## **INTRODUCTION**

This application seeks to amend the proposals from two duplex apartments to a single house with specific features

Kidderpore Hall Level LG Proposed GA Plan

Extract of Proposed Lower Ground Floor showing Pool and Spa

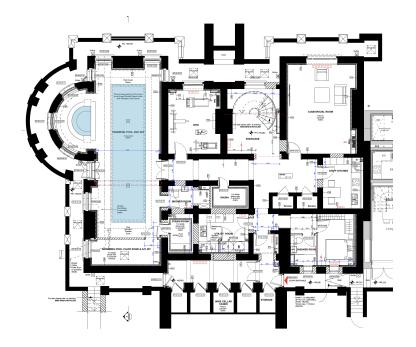
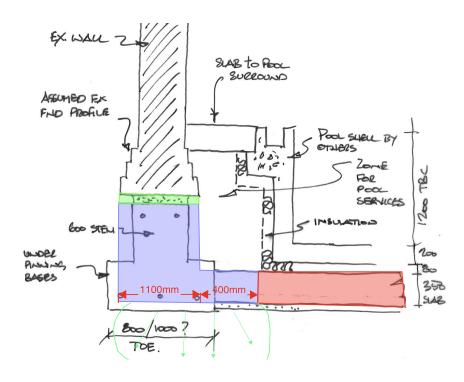
The original consent, LPA Ref: 2015/4116/L, included the provision of a private pool and spa to lower ground floor level, with the necessity to structurally underpin the area around the pool. It is now proposed to reintroduce this facility with the associated works.

It is proposed to reintroduce a pool and spa to the western area of the lower ground floor. The pool,  $10m \times 2.5m \times 1.35m$  deep will sit within a sunken area, together with an adjacent recessed spa. The pool plant will be located at the southern end of the space, together with air conditioning equipment, vented through the external wall to the lightwell (below main ground level).

To facilitate the pool, spa and below ground servicing, it will be necessary to underpin the adjacent load bearing walls to allow excavation below existing floor level.

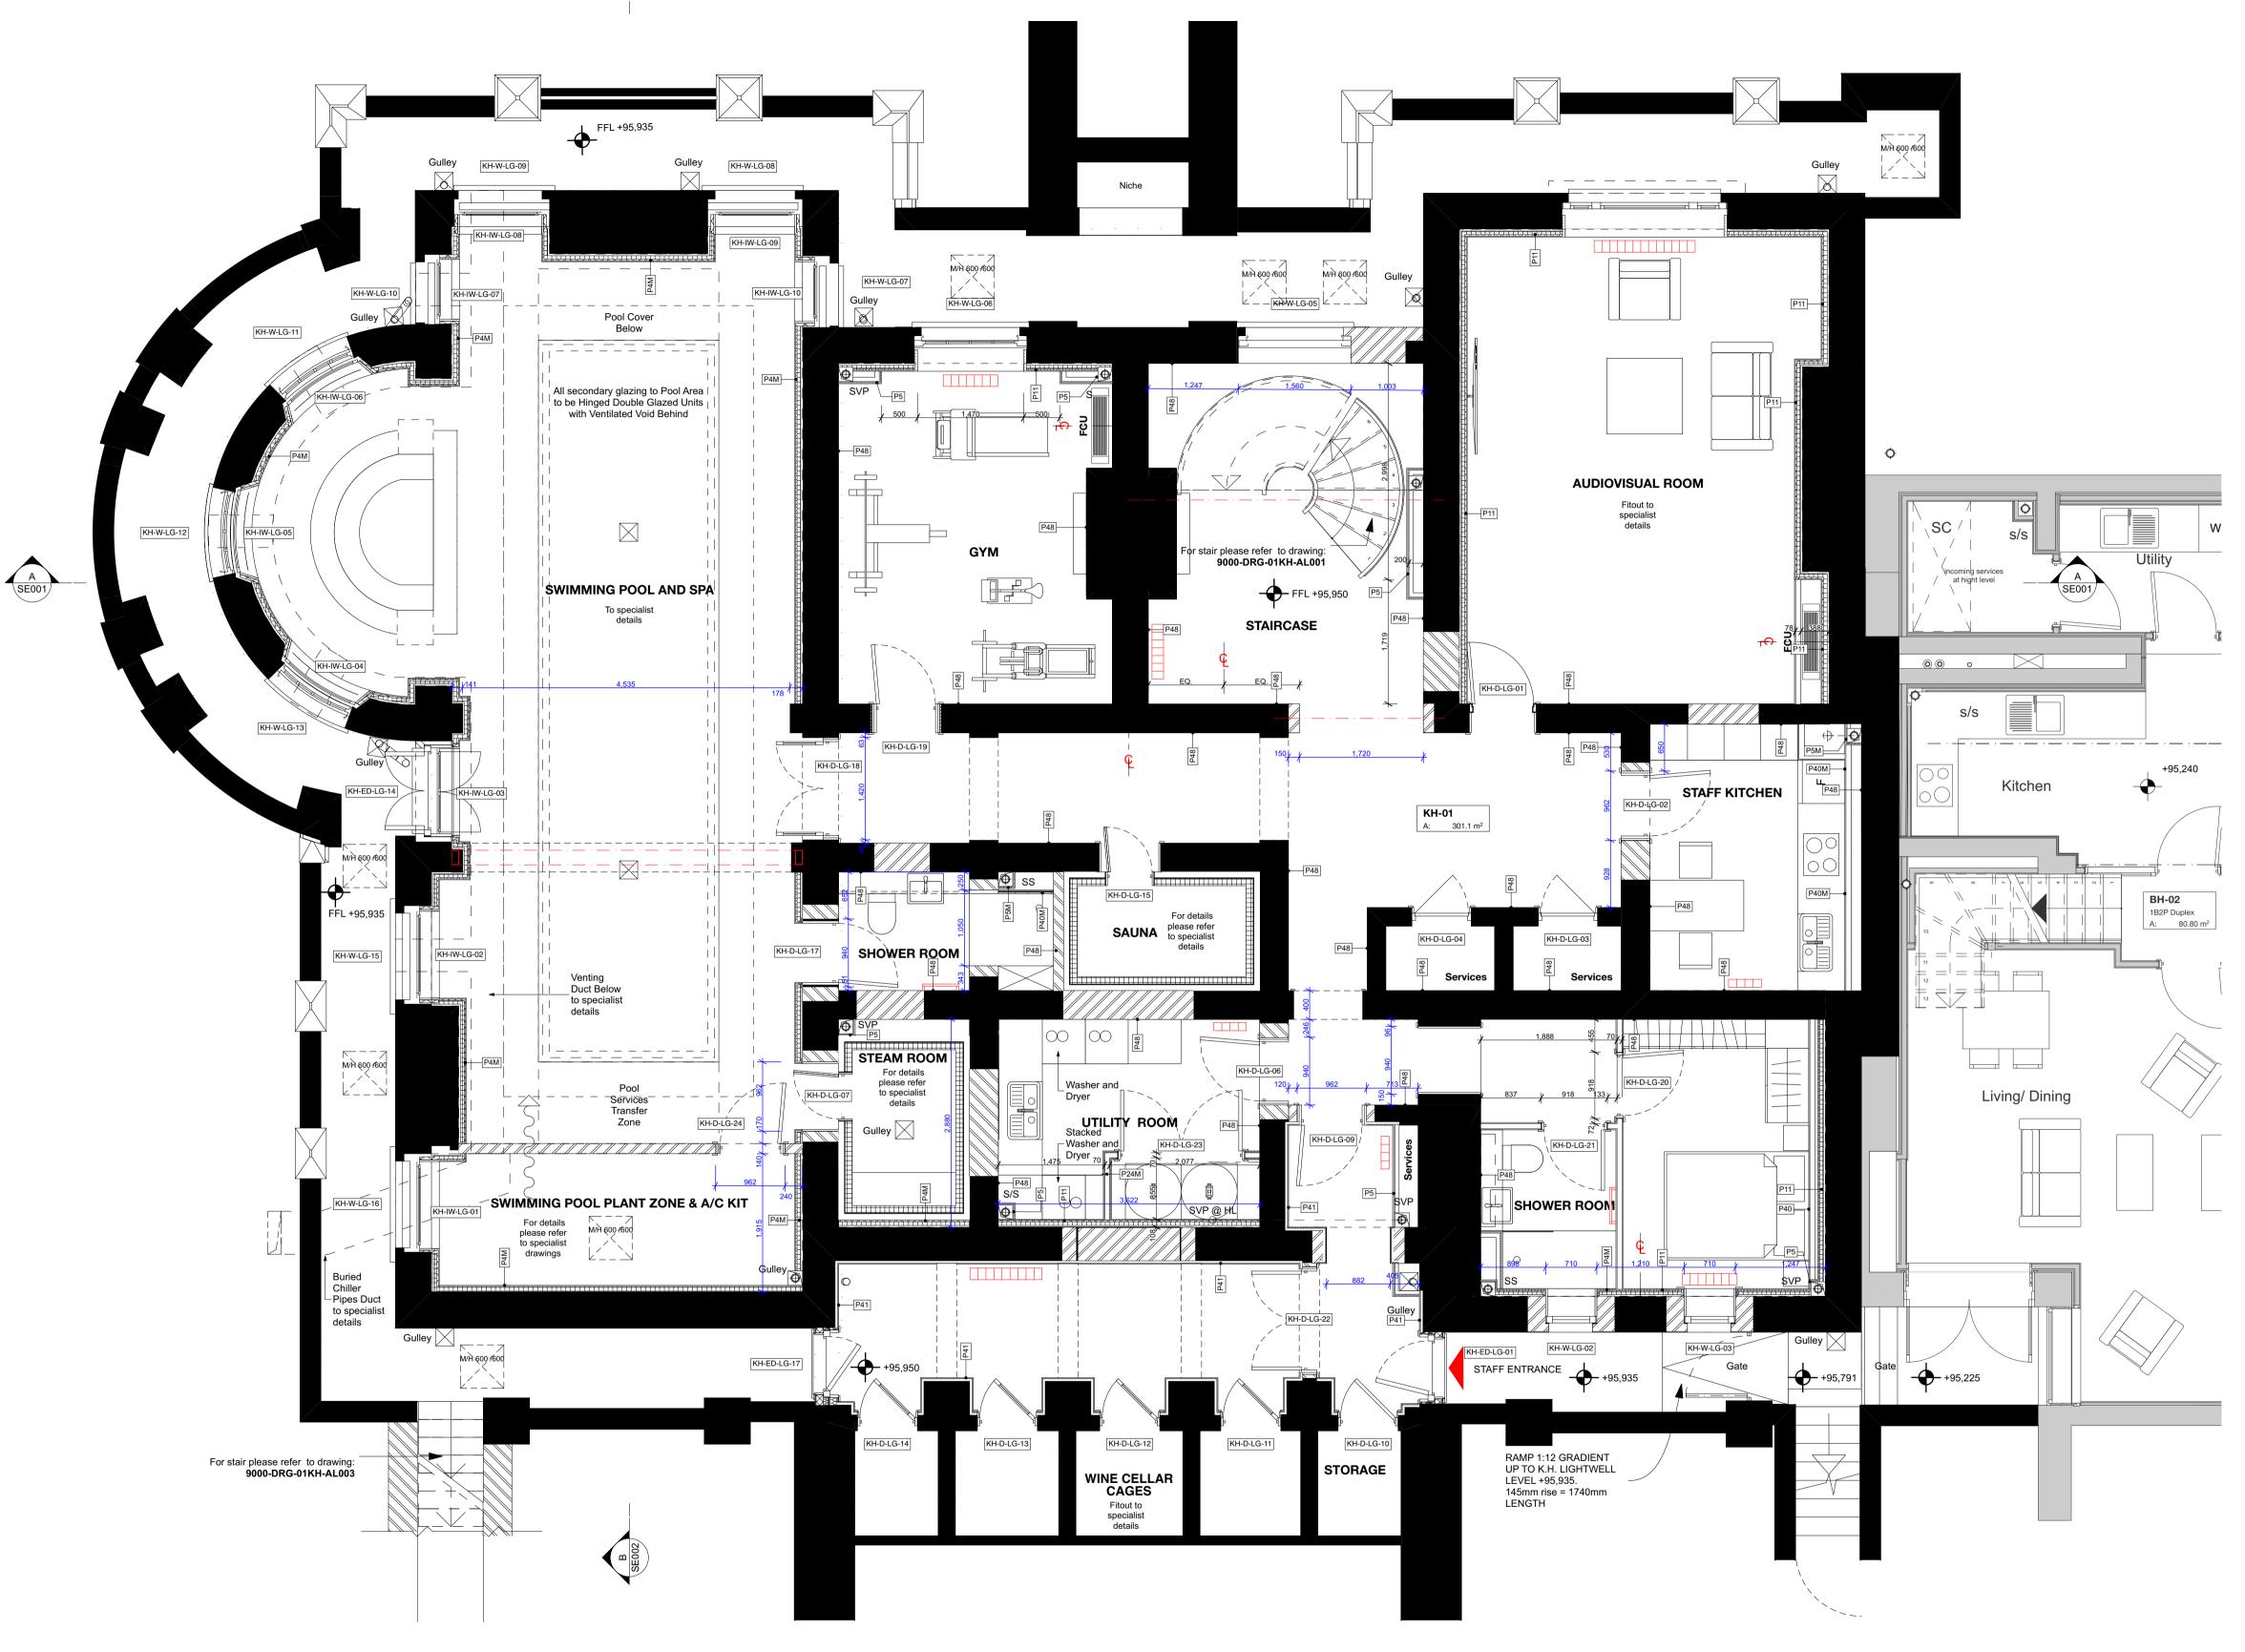
In order to open up the space between the previously approved Play Room and Bedroom 3 in order to form the Pool Hall, the wall separating the two spaces needs to be removed.

Tully De'Ath, the Structural and Civil Engineers on the project, propose a steel 'goal post' replacement structure to support the floor and wall above, as illustrated on their drawings 9100-DRG-03KH-UG001, 9100-DRG-00KH-LG001 and UG001.

Extract from Tully De'Ath Drawing 9100-DRG-34KH-LG217

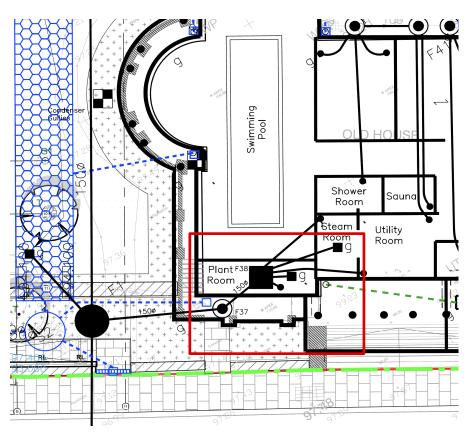
In order to now install the sunken pool, some drainage, which had been installed under the 2017 approval, needs to be diverted due to invert levels. This amendment, with two new manholes, is shown on their drawing 9100-DRG-34KH-LG217.

DRAWING No. DRAWN BY KrC 15 230 REV 9000-DRG-03KH-UG010 c7

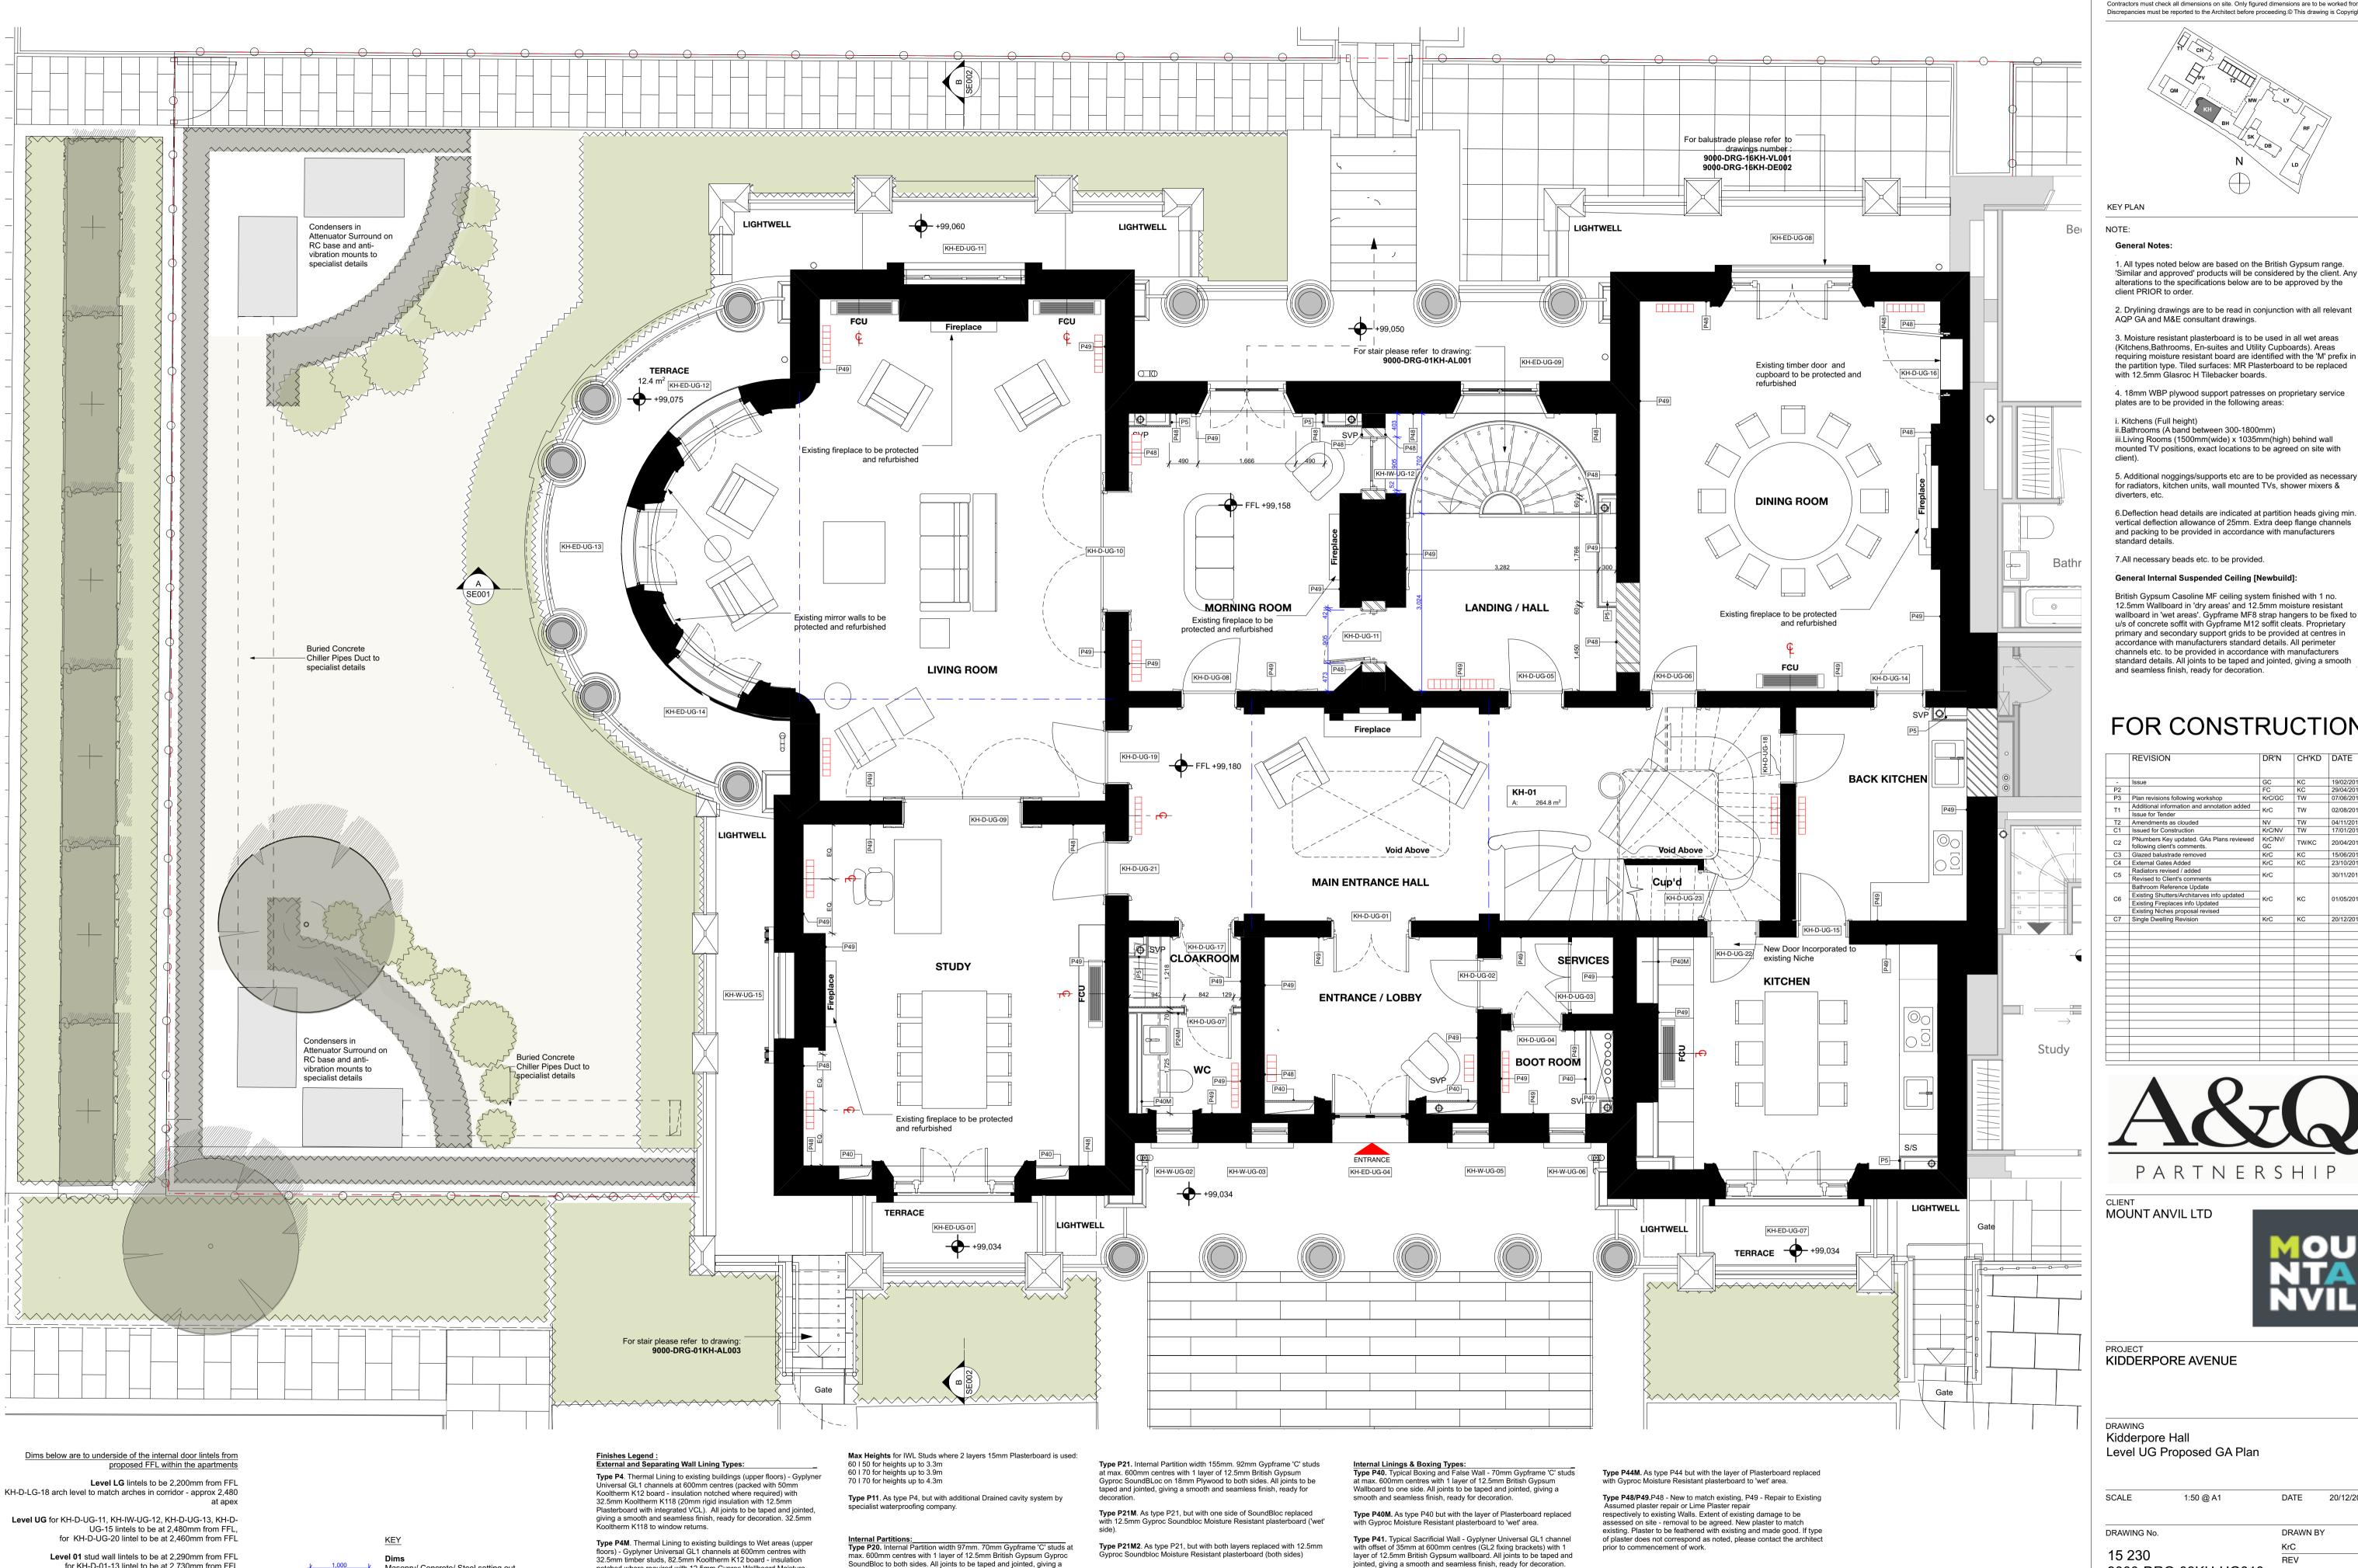
As part of the increased servicing of the larger property, the extent of mechanical cooling requires a localised source of chilled water. It is proposed to locate four Condenser Units within specialist attenuated enclosures within the garden area as illustrated on drawing 9000-DRG-03KH-UG010, screened within the landscaping. An underground concrete duct will connect the condensers together and deliver the pipework to the Pool Plant room, routed under the external lightwell.

The enclosures are Environlite T6-1300, painted RAL 9015 (Olive Black) mounted on anti-vibration mounts. The projects Acoustic Engineer SOL Acoustics has reviewed the acoustic assessment of the enclosures in relation to their position. Their letter of 3rd December 2018 confirms compliance with the original Planning Consent requirements. This letter and product details set out the acceptability of the proposals.

New access steps are proposed from street level to lightwell level.
